PD Modification Application: MM 22-0671

**Hillsborough
County Florida**

Development Services Department

1.0 APPLICATION SUMMARY

2.5 Proposed Site Plan OPTION C (partial provided below for size and orientation purposes. See Section 8.2 for full site plan)

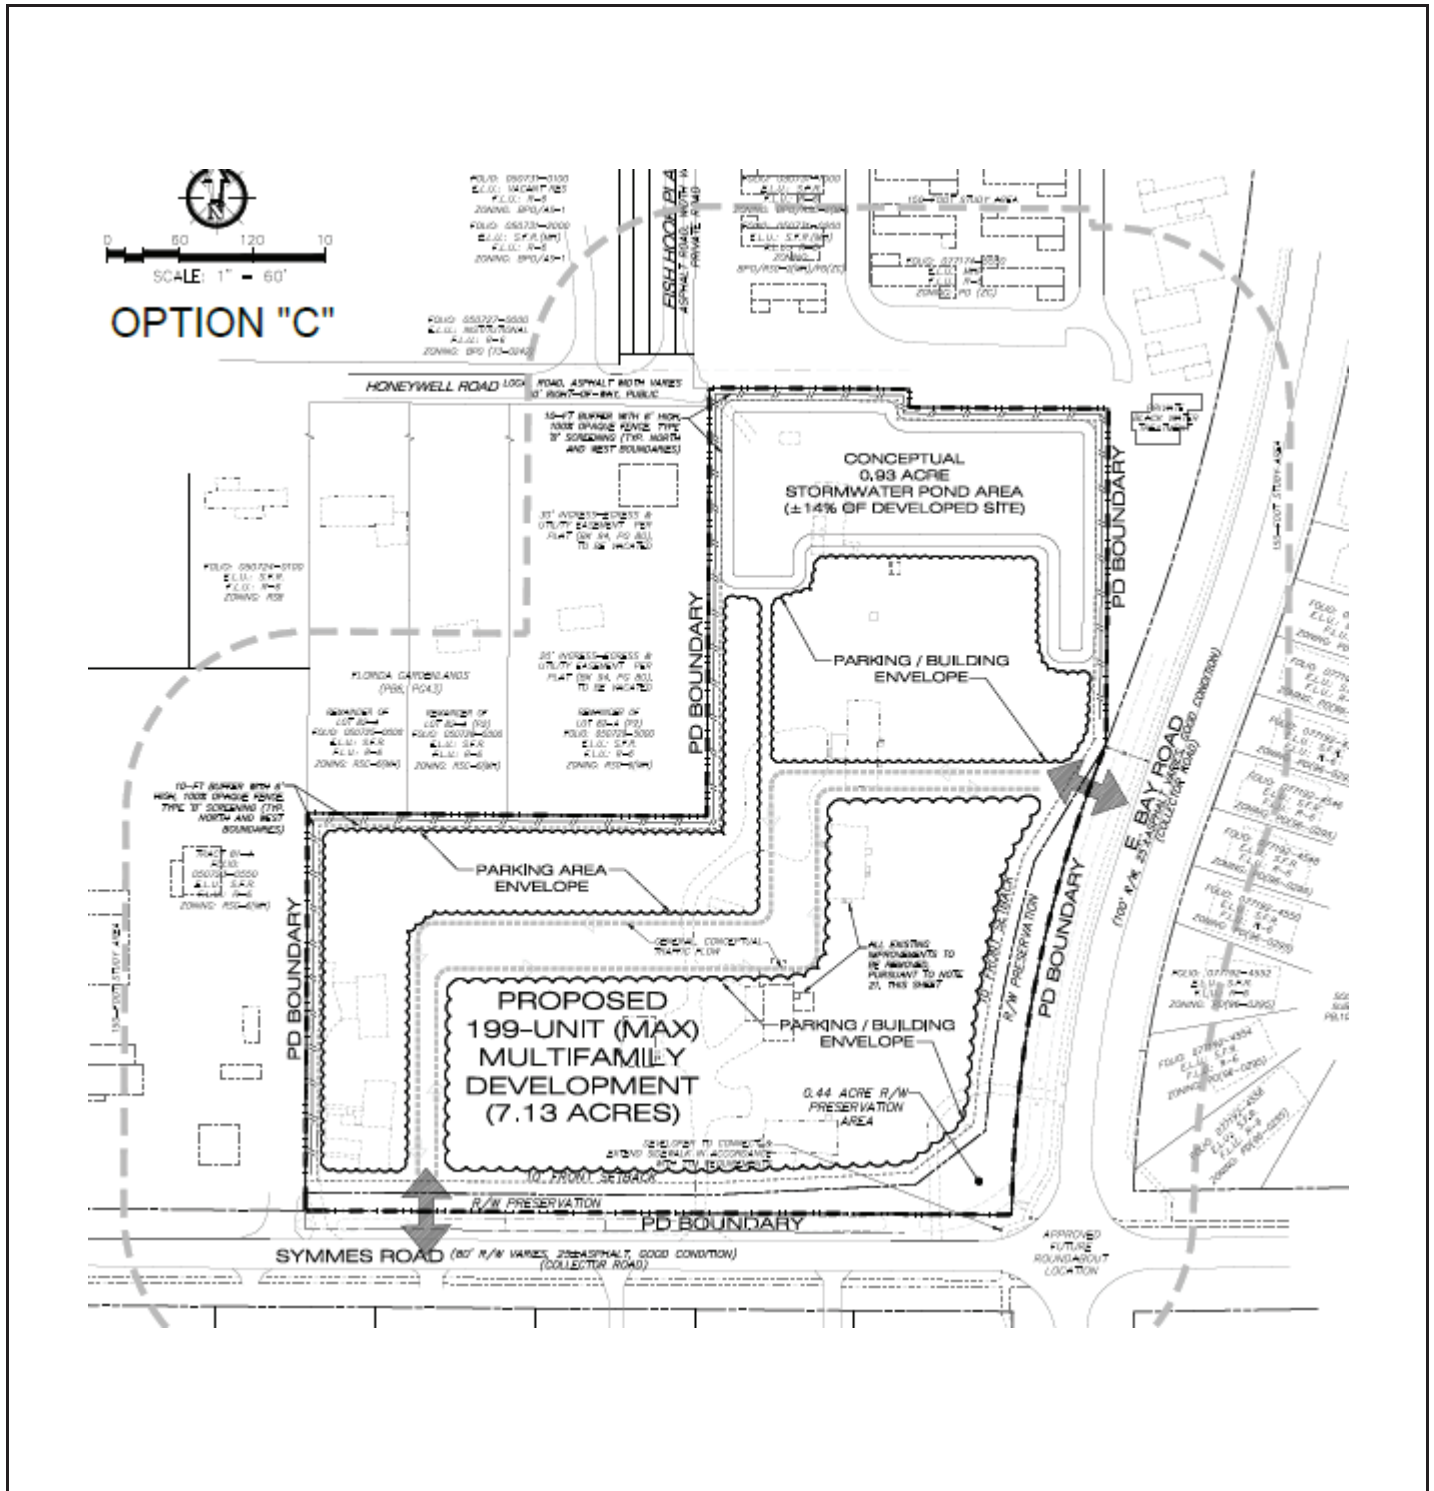
The applicant proposes a 3rd development option consisting of a multi-family development for up to a maximum of 199 units with a maximum height of 65 feet/4 stories. Staff notes that the applicant initially requested up to 249 dwelling units with Affordable Housing or Infill Development Density Bonuses. However, the applicant subsequently revised the request for a maximum of 199 multifamily dwelling units pursuant to compatibility concerns.

Option B (Townhome development)

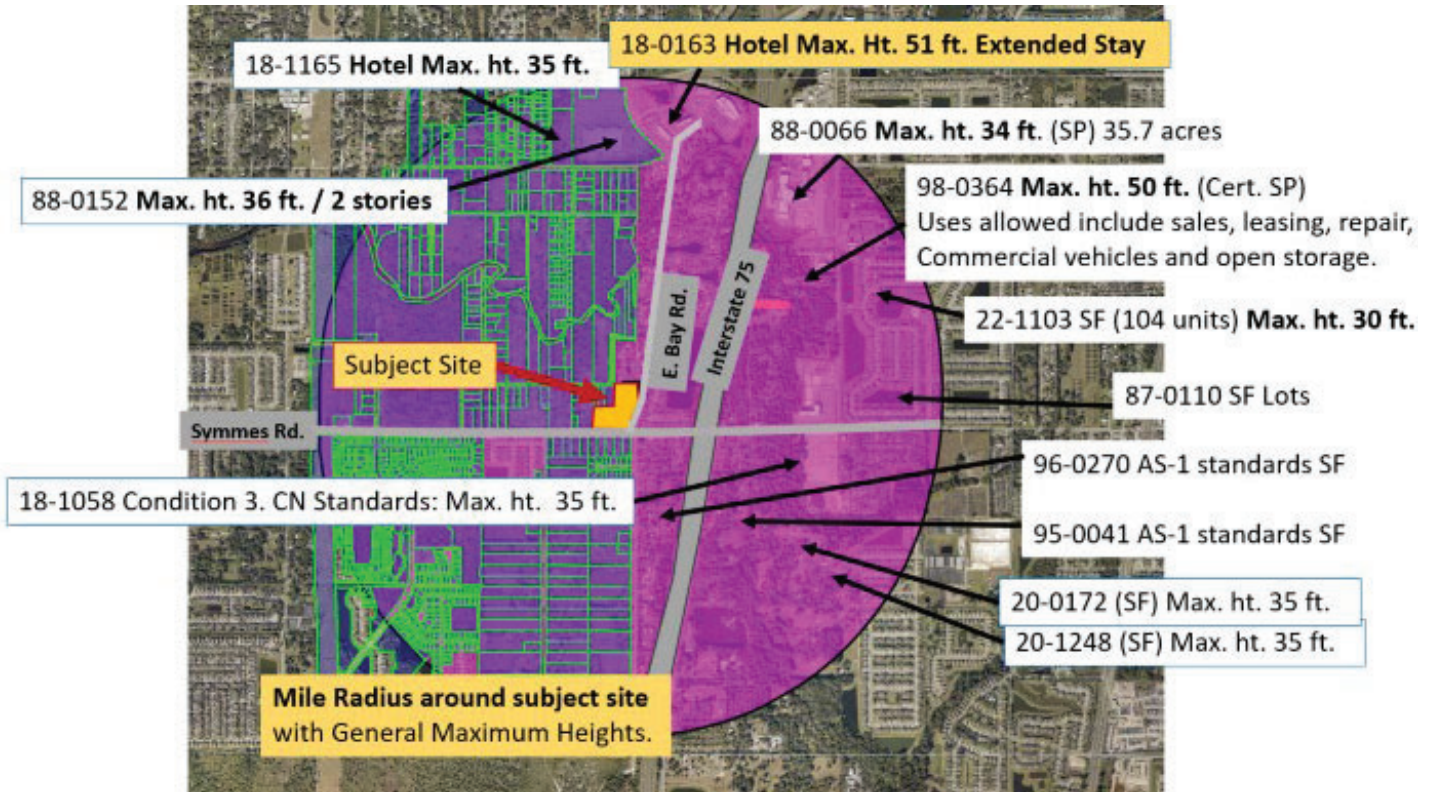
The applicant intends to modify approved development Option B (formerly Option 2). More specifically, the applicant proposes to [1] amend Option B to increase the number of residential townhomes from 64 dwellings to 110 dwellings. Pursuant to the increase in units the applicant proposes to reduce the lot width for the individual townhomes from 25 feet to a minimum of 18 feet width. The applicant is also proposing to allow a 10-foot height increase from 35 ft. to 45 ft. The RMC-20 zoning district allows a maximum height of 45 feet and is an implementing zoning district within the Residential-20 future land use designation. The increase the number of dwelling units would be consistent with the FLU allowable density if the companion comprehensive amendment is approved.
